ITB 2017-170 – Addendum 1

Pre-bid Meeting Minutes – Addendum No 1

[ITB 2017-170:]: Lot 14C- Rehabilitation Works of Islamic University of Gaza -Phase C
(Conference Hall Building).

Issue Date: 17 July 2017

واجهة القبة

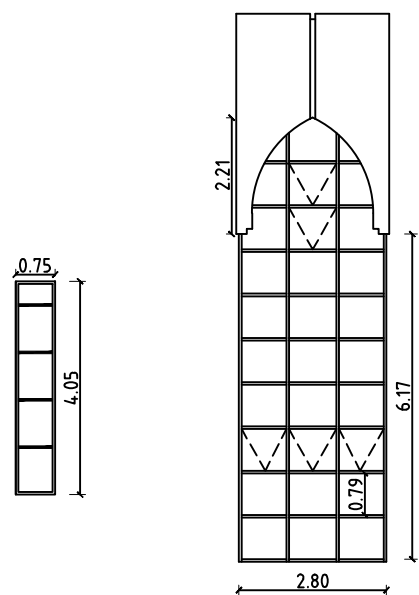
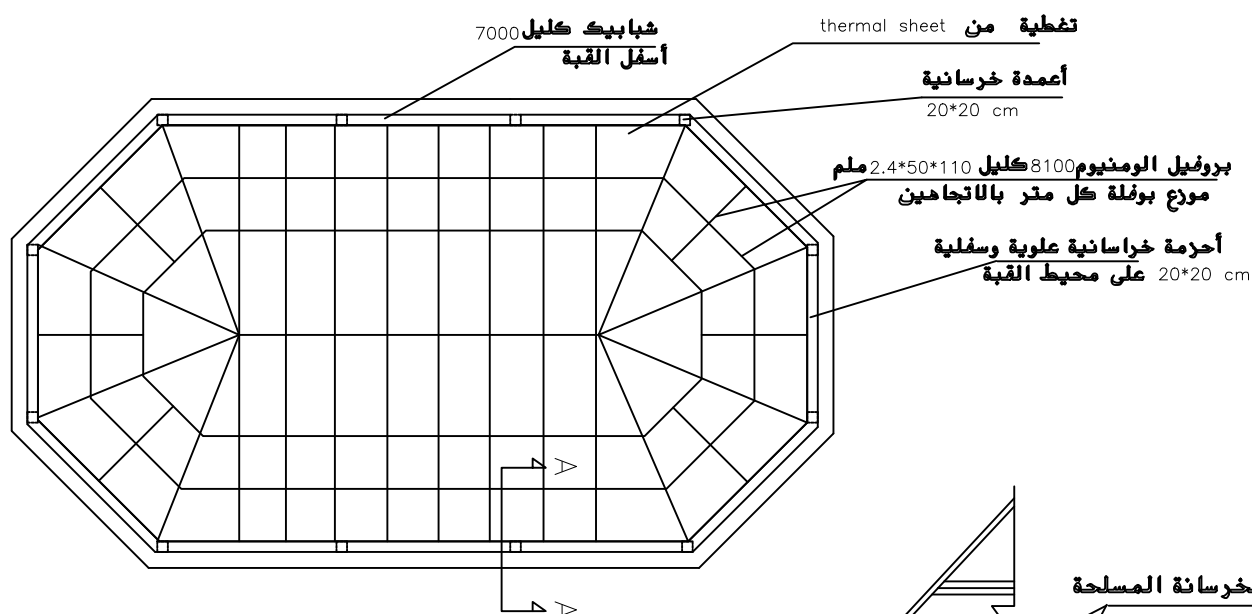
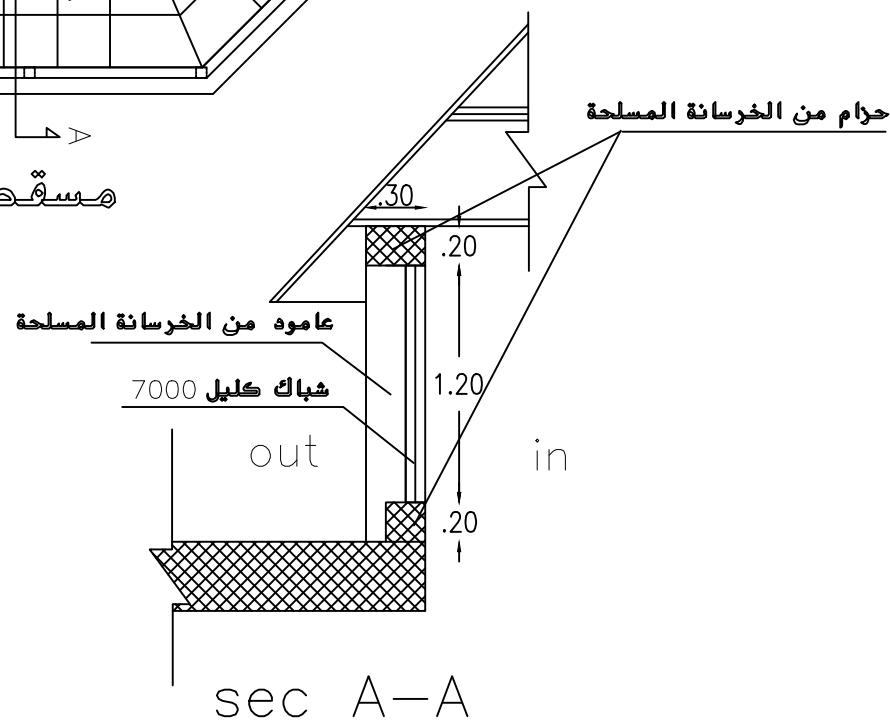
28. Item 4.1/Bill (4)/ Aluminium & Metal Works/: the glass is 10 mm thickness which is surrounded/ covered with Aluminium section type 2000 for doors.
29. Item 4.21/Bill (4)/ Aluminium & Metal Works/: Type of Aluminium in Dome is 8400.

30. Item 4.21 /Bill (4)/ Aluminium & Metal Works/: the glass is 10 mm thickness.
31. Item 4.21 /Bill (4)/ Aluminium & Metal Works/: Size of Ceramic or Granite mosaic tile 2*5 cm.

38. Attached Details of Dome and windows.
